MEMORANDUM

TO: District of Columbia Board of Zoning Adjustment

DATE: November 17, 2017

SUBJECT: BZA Case 19599 - Request for special exception for 4200 Davenport Street, expansion and consolidation of the Georgetown Day School private school (Square 1672 – Lots 4, 14, 804, 812, 815; Square 1673 – Lots 822, 824)

Figure 3. Proposed Site Plan

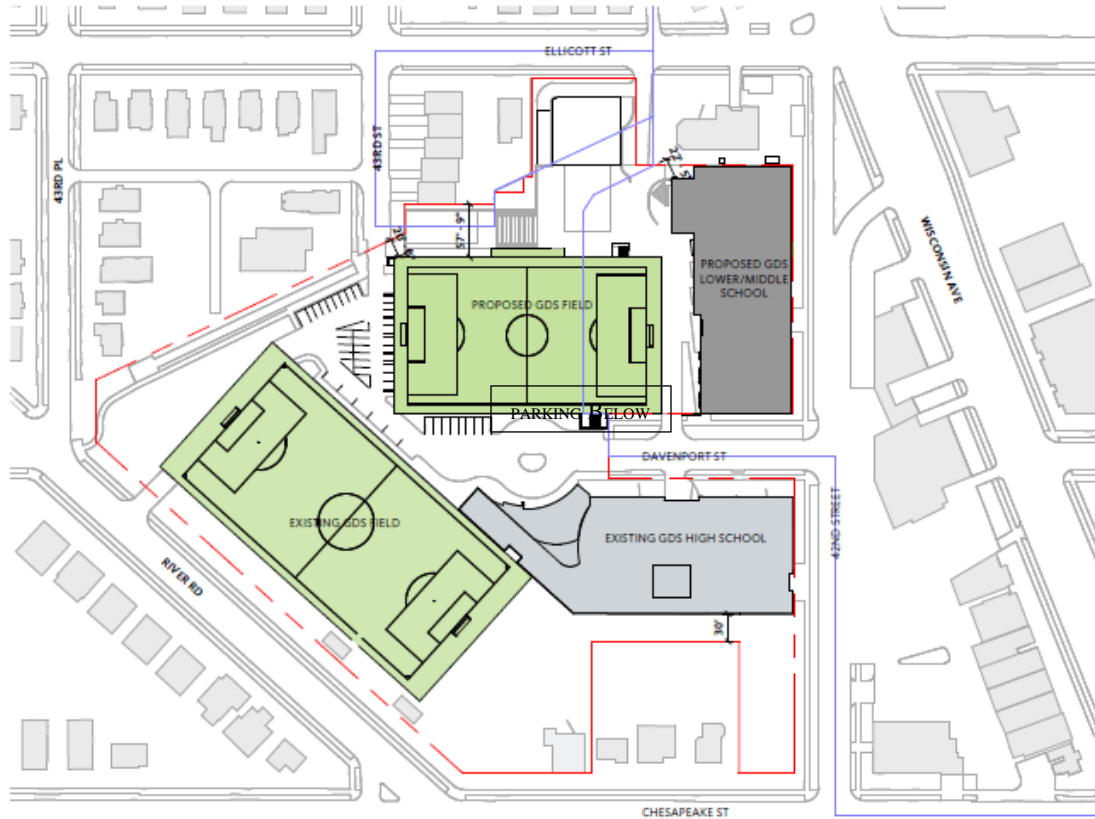
- The applicant should explain how the landscaping illustrated on Sheet G0.11 of Exhibit 41A1 will screen the lighting of the above-grade portion of the proposed garage from the rear yards of adjacent residences on 43rd Street and Ellicott Street.

- **Perimeter Landscaping:** The streetscape illustrations shown on Sheet A9.04 of the Pre-hearing statement (Exhibit 41A1) make clear that while the applicant would provide superior landscaping inside of the campus, it has not proposed to provide an equivalent level of landscaped environment on the project’s perimeters.

- *OP recommends the applicant make every effort to meet with the staff of the public space committee for an informal consultation in order to present more refined proposals for the perimeter landscaping at the public hearing.*
